The Commission has issued the enclosed Amendment No. 59 to Facility Operating License No. DPR-49 for the Duane Arnold Energy Center (DAEC). This amendment consists of changes to the Technical Specifications in response to your application dated January 22, 1980.

This amendment is associated with the fourth refueling of DAEC and changes the Technical Specifications to (1) include prepressurized 8x8 retrofit fuel, (2) revise operating limit minimum critical power ratios, and (3) incorporate administrative improvements.

Amendment No. 59
License No. DPR-49

ATTACHMENT TO LICENSE AMENDMENT NO. 59

FIGURE 3.12-7

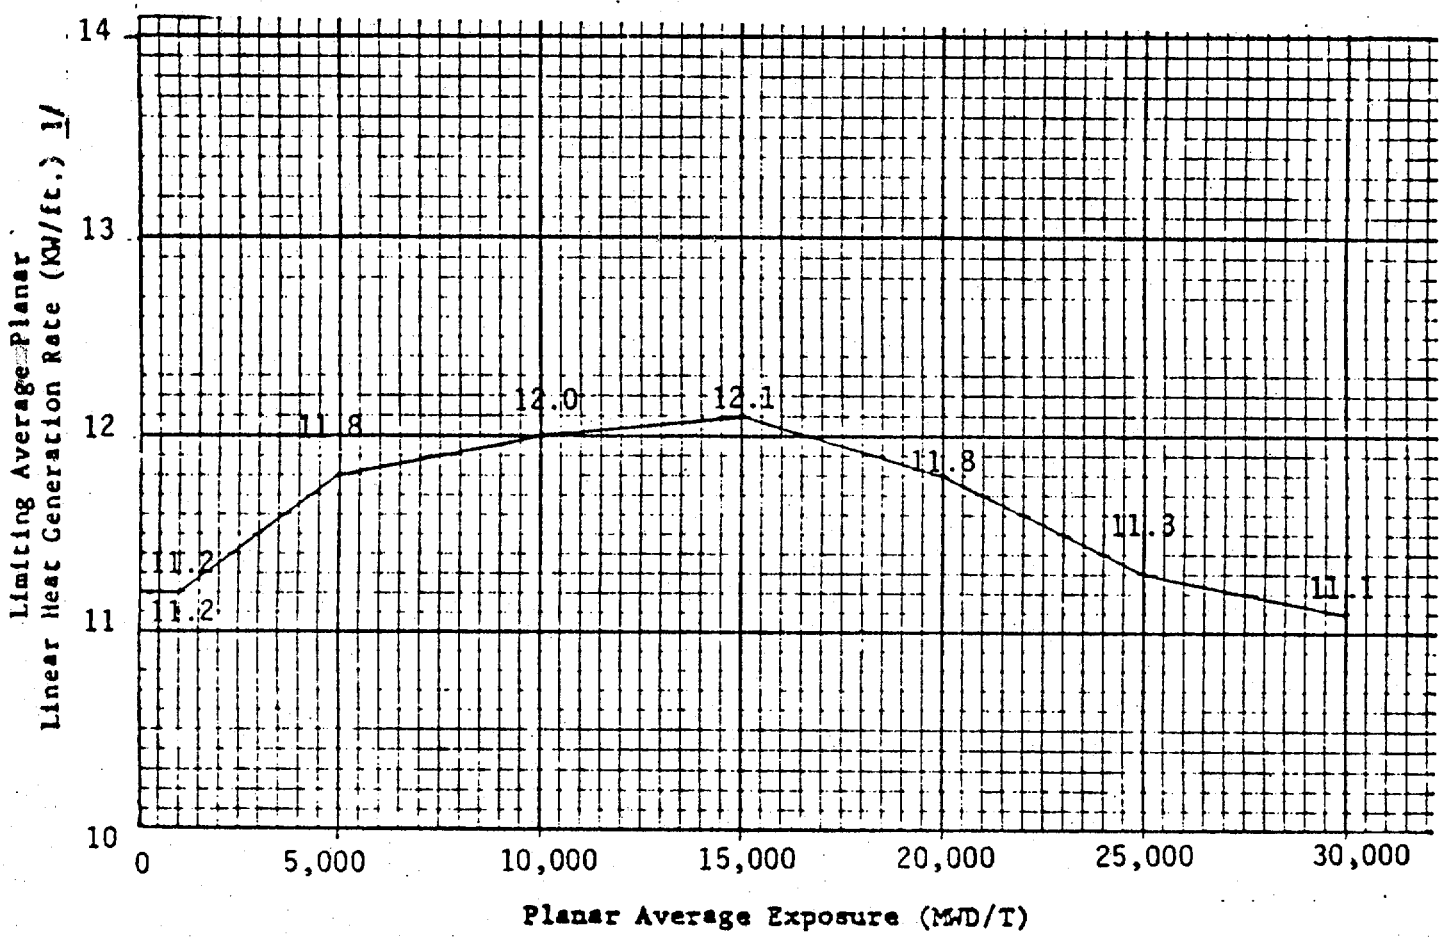
During reactor power operation, the actual MAPLHGR for each type of fuel as a function of average planar exposure shall not exceed the limiting value shown in Figs. 3.12-2, -3, -4, -5, -6, and 7. If at any time during reactor power operation it is determined by normal surveillance that the limiting value for MAPLHGR (LAPLHGR) is being exceeded, action shall then be initiated within 15 minutes to restore operation to within the prescribed limits. If the MAPLHGR (LAPLHGR) is not returned to within the prescribed limits within two hours, the reactor shall be brought to the cold shutdown condition within 36 hours. Surveillance and corresponding action shall continue until the prescribed limits are again being met.

1/ When core flow is equal to or less than 70% of rated, the MAPLHGR shall not exceed 95% of the limiting values shown.
